Change Order Request

Williamson County Expo Center

Change Order Request: 014**Date: 7/28/2016**

Additional Scopes Via ASI ESI and RFI

SHT NO: XS-10
DATE: 07/12/16
BY: JS

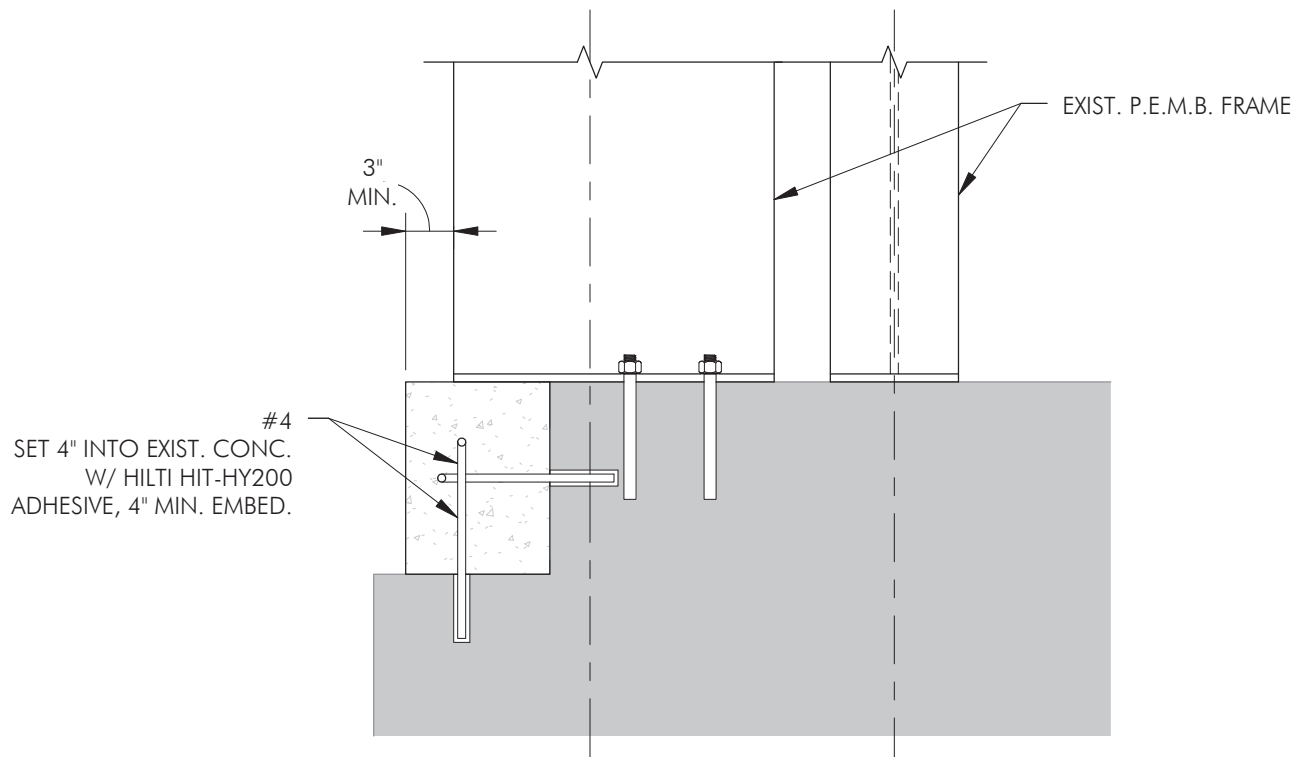
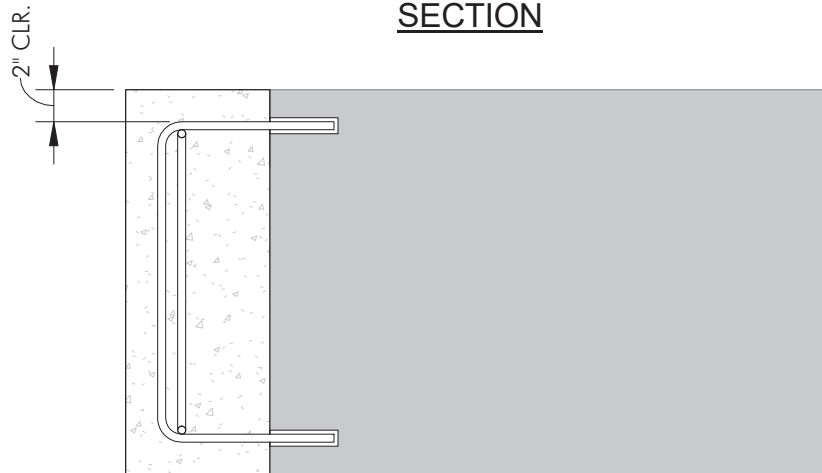
ESI-007 - Penning Footing Pedestals

Extend footing pedestals at 4 ea. Penning footings to allow PEMB Portal Framing columns to have full bearing.

Extend footing pedestals to allow PEMB Portal Framing Column to have full bearing as shown on attached drawing.

Additional 6" Concrete Paving

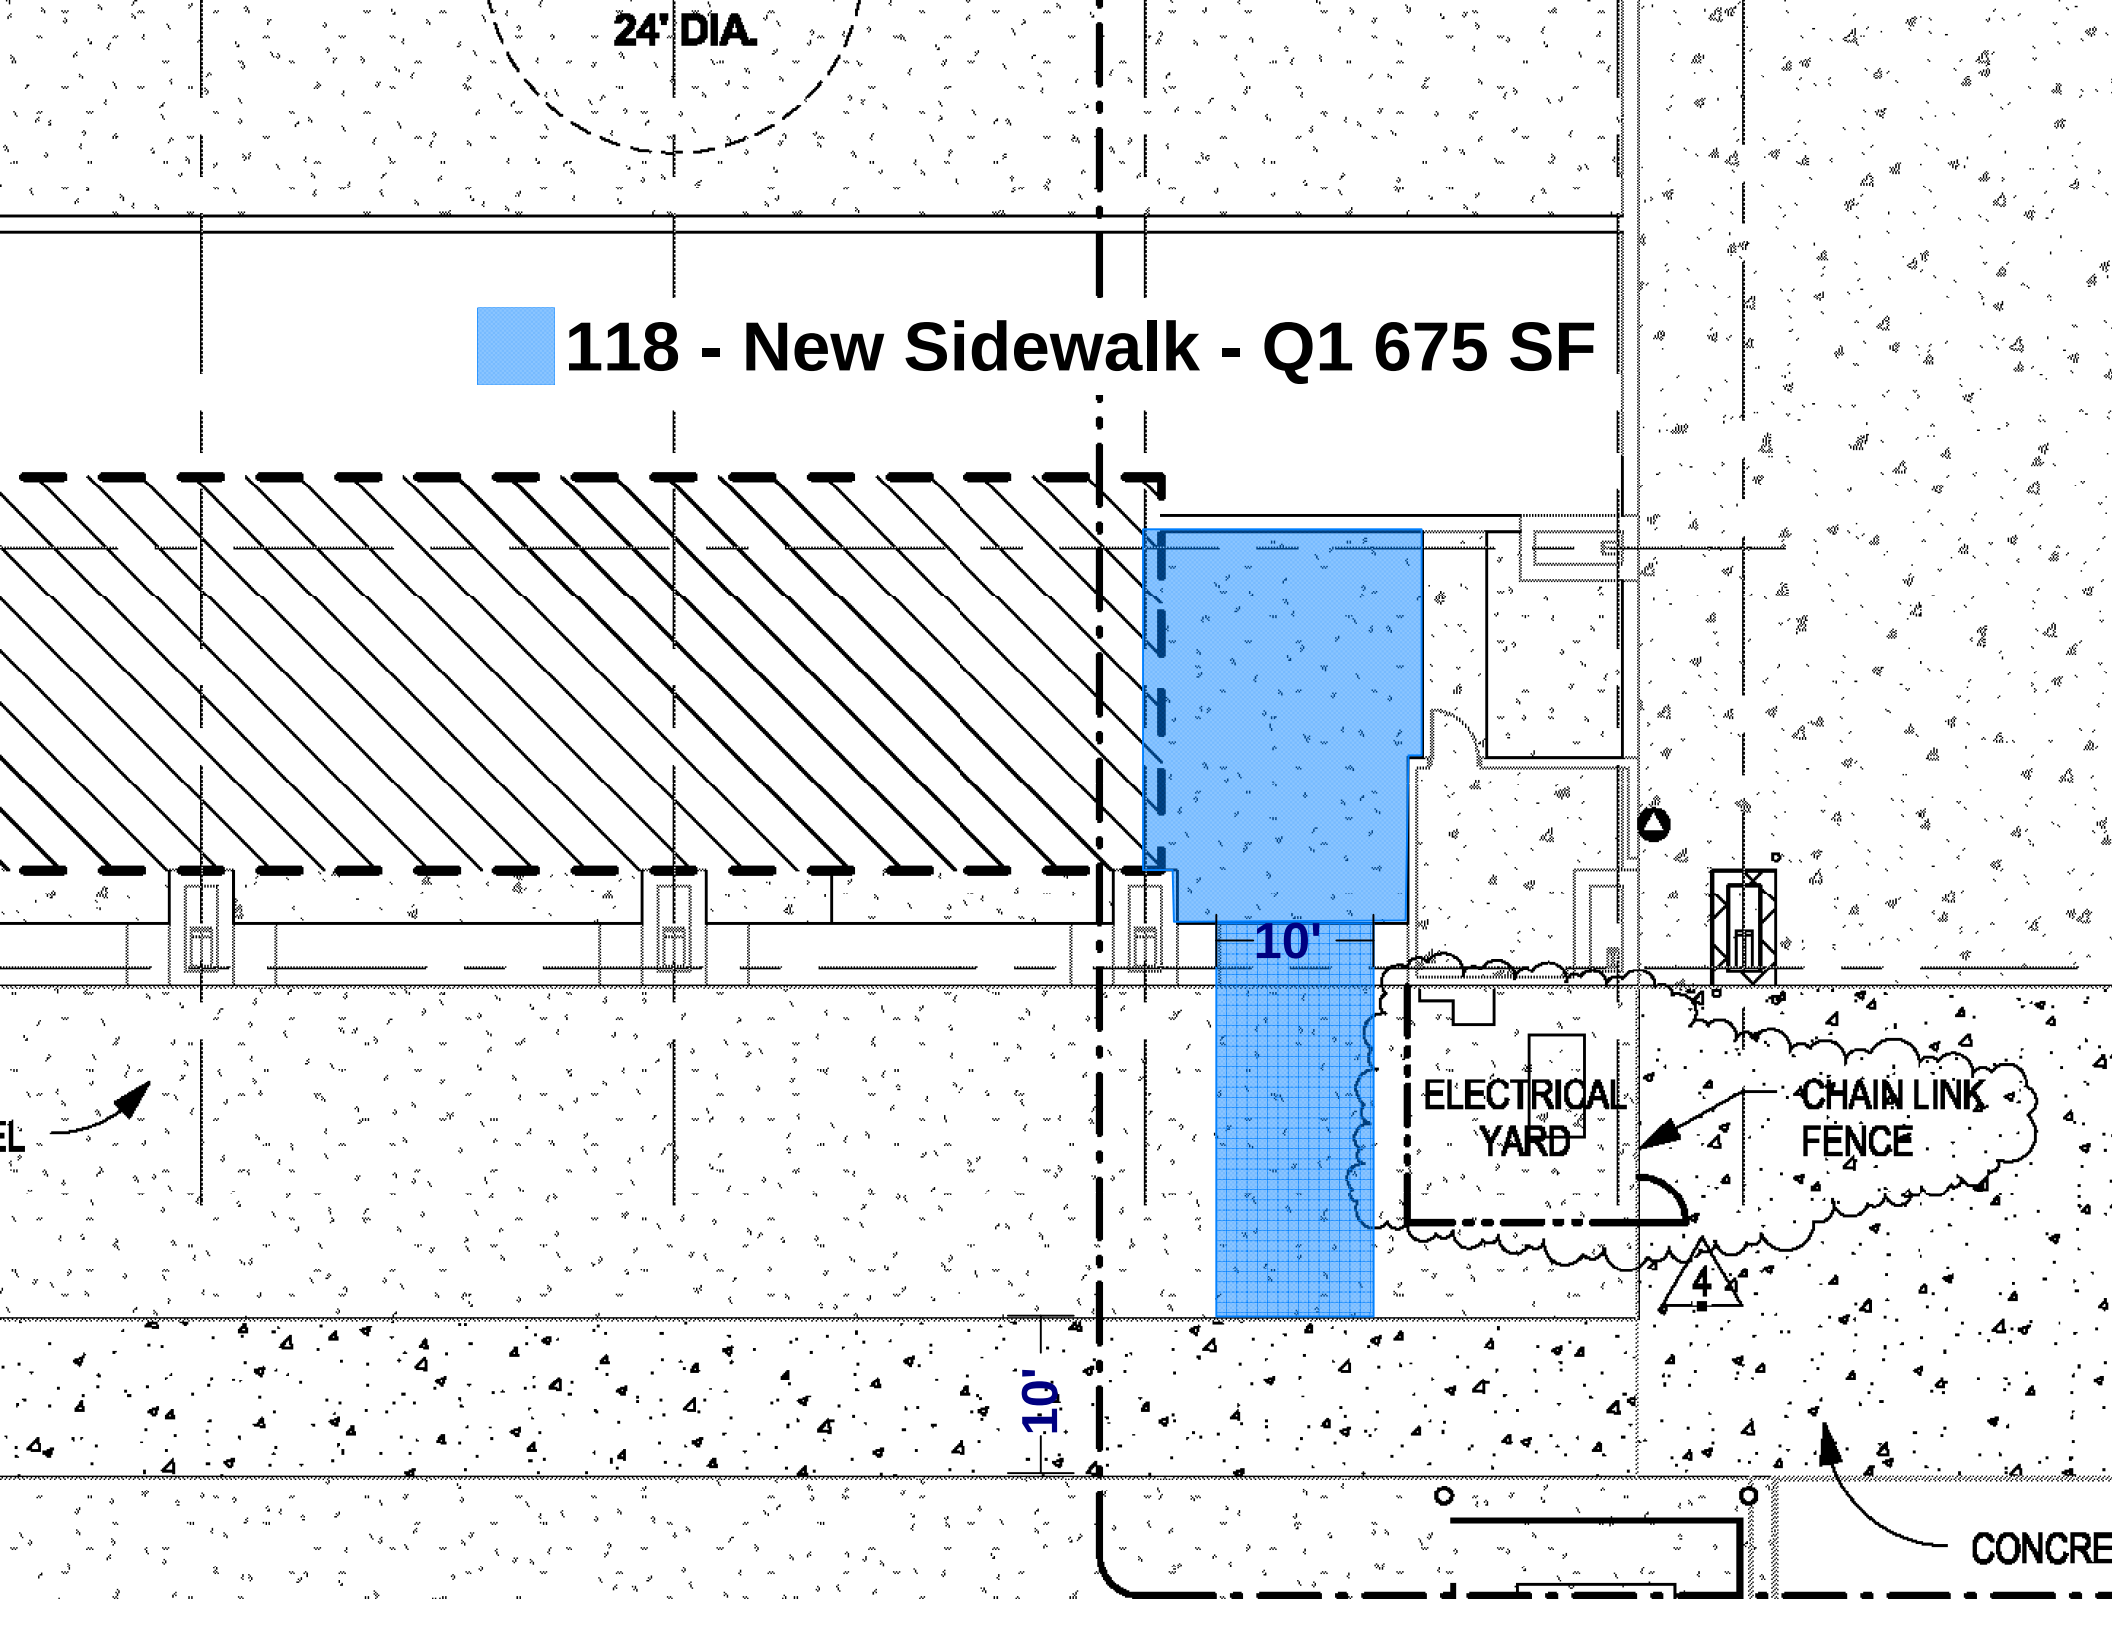
Install additional 6" concrete Paving sidewalk from bleacher area to new sidewalk leading to

Install 6" Concrete Paving

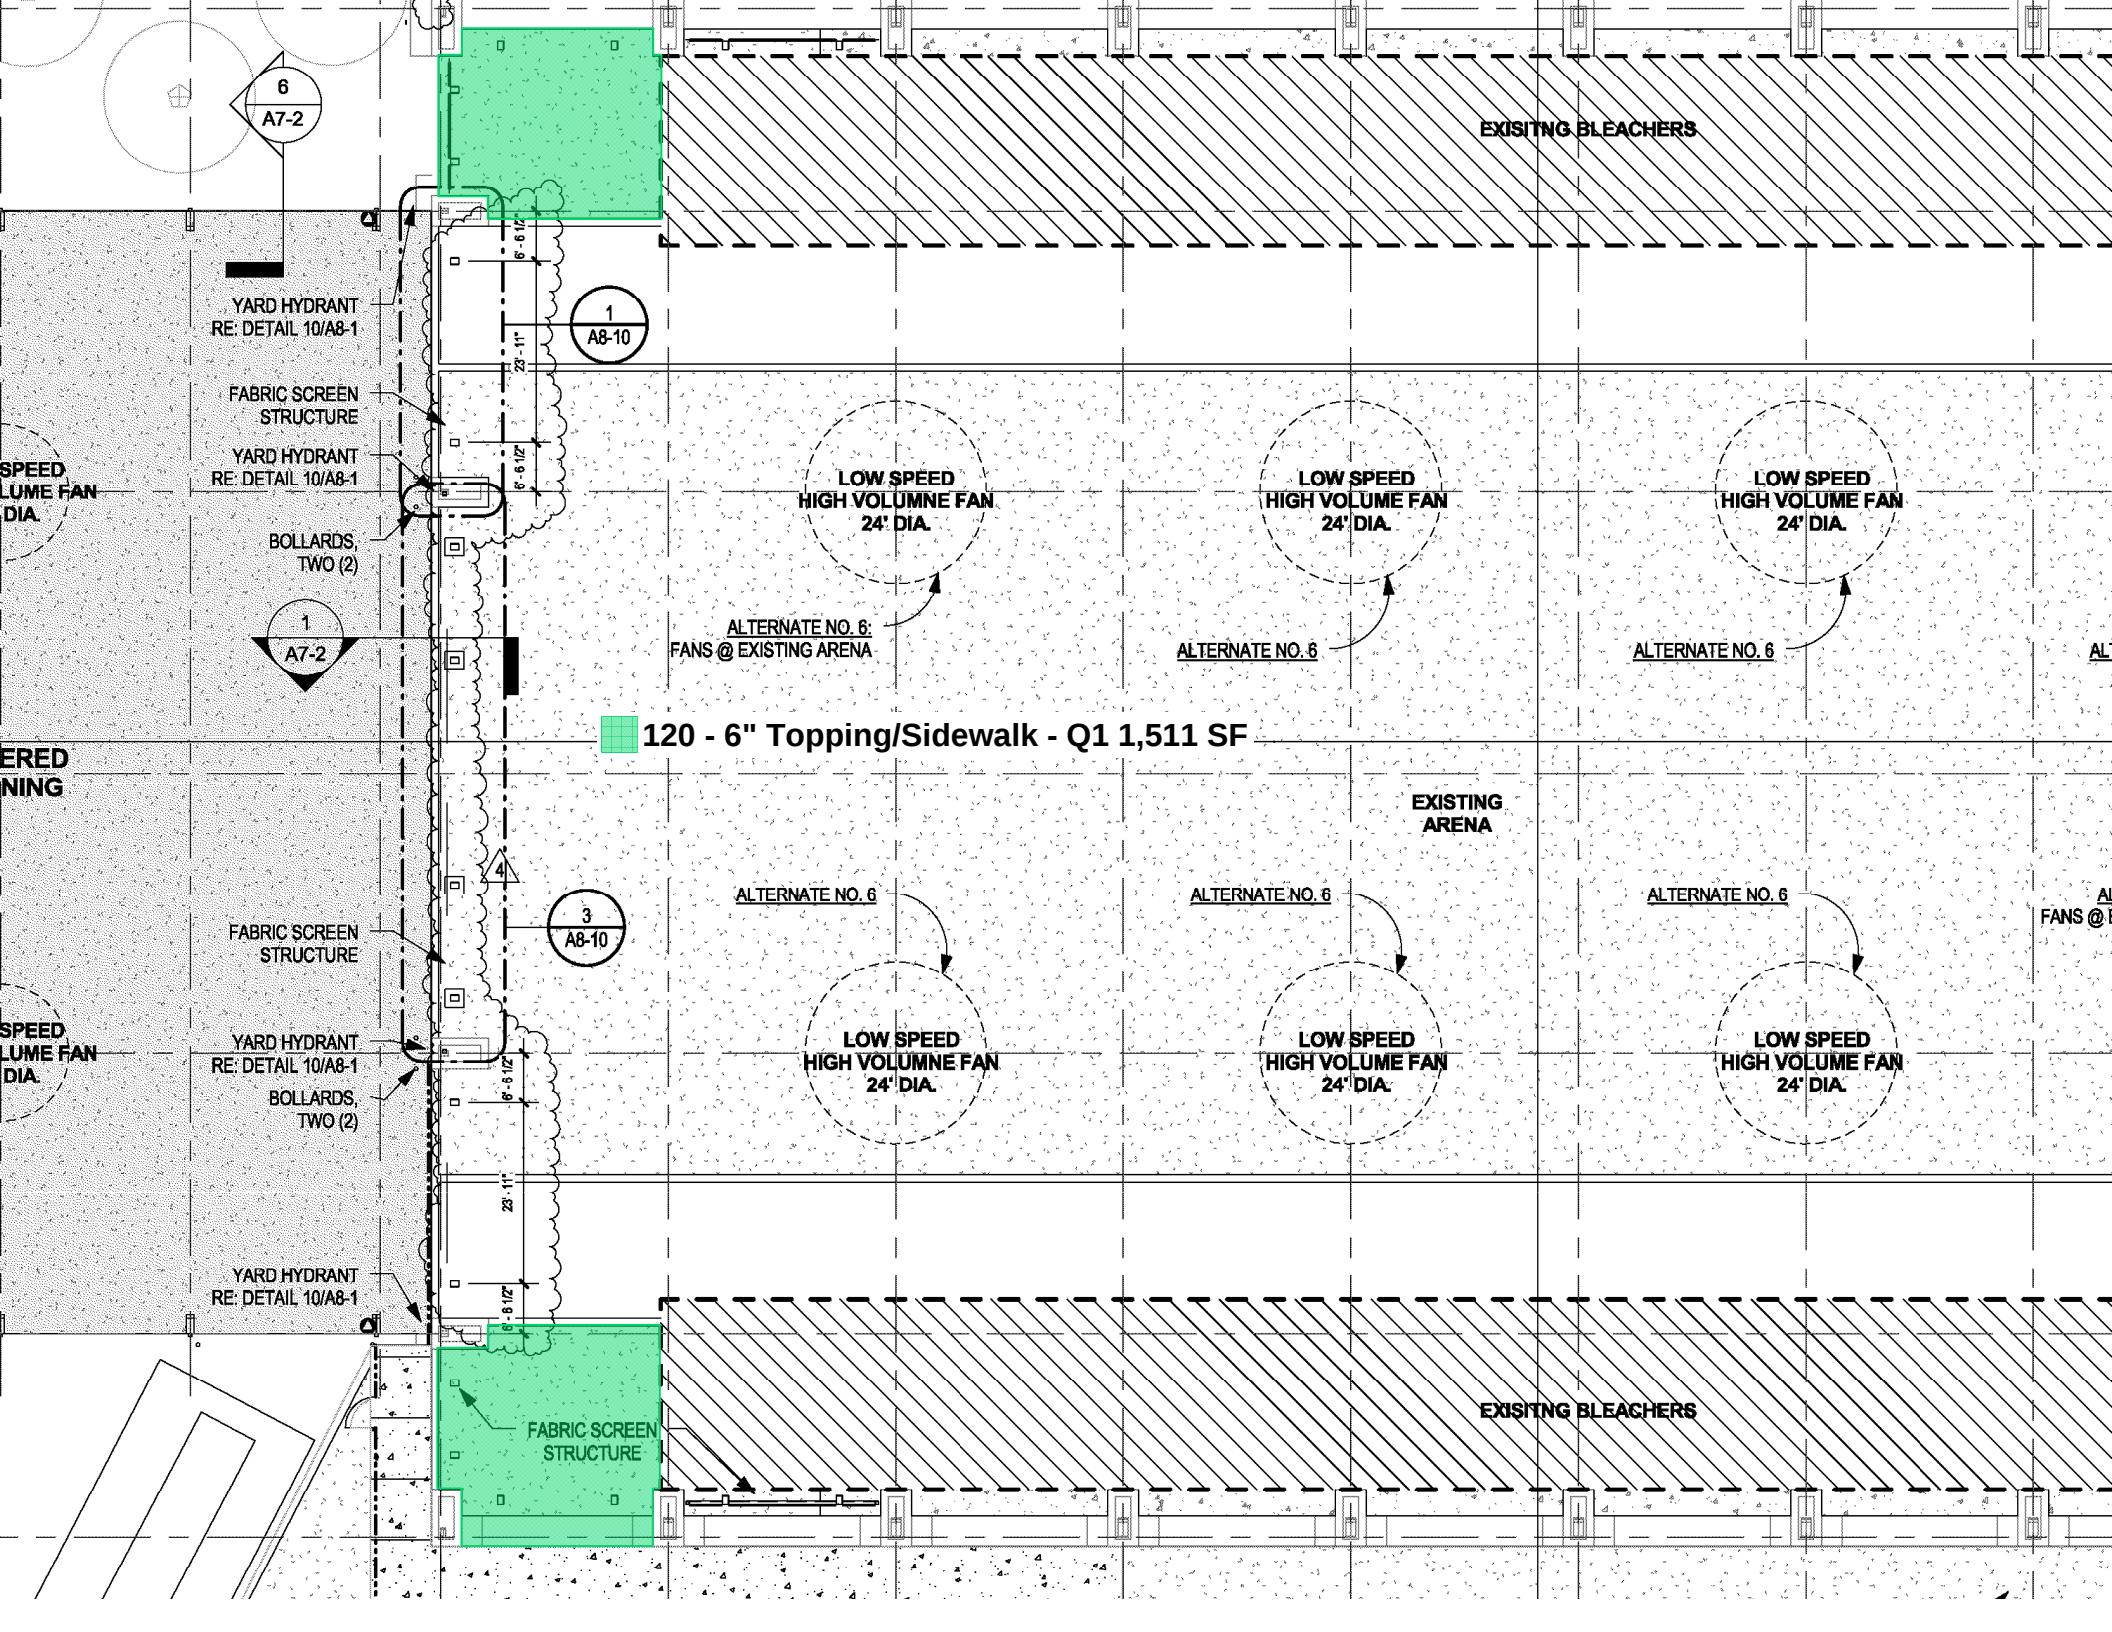
Install 6" concrete paving on top of footings and decomposed granite at 2 locations at north end of existing arena to create pedestrian access. See attached drawing for locations.
